# ERRATA SHEET

**Date:** 2008 Mar 10  
**Document Release:** Version 1.3  
**Device Affected:** P89LPC913

Figure 1: Flowchart ICP Global Erase

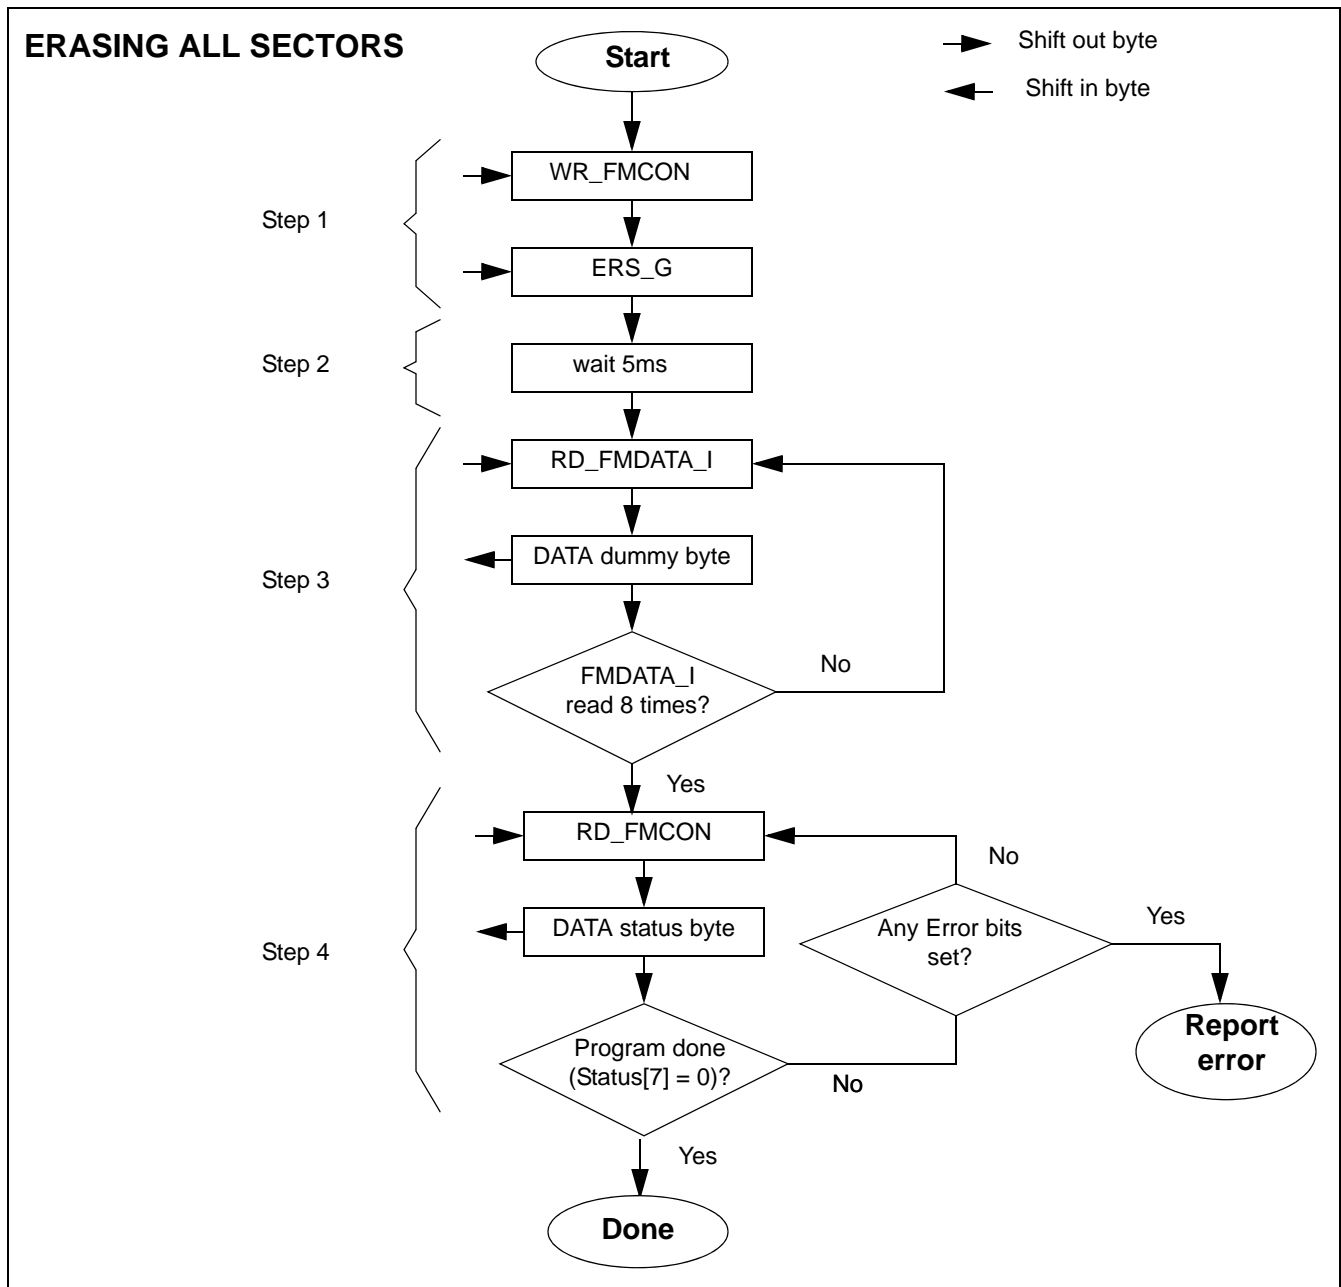
**Problem:** When giving the Erase Global command through the ICP interface the LPC913 will not clear the busy flag and stay busy forever.

**Workaround:** The workaround can be done in 4 steps:

Step 1: Shift out the WR\_FMCON command followed by the Erase Global opcode.

Step 2: Wait 5ms.

Step 3: Do 8 dummy reads with the RD\_FMDATA\_I command.

Step 4: Read FMCON until the busy flag gets cleared.

Please also see figure 1.
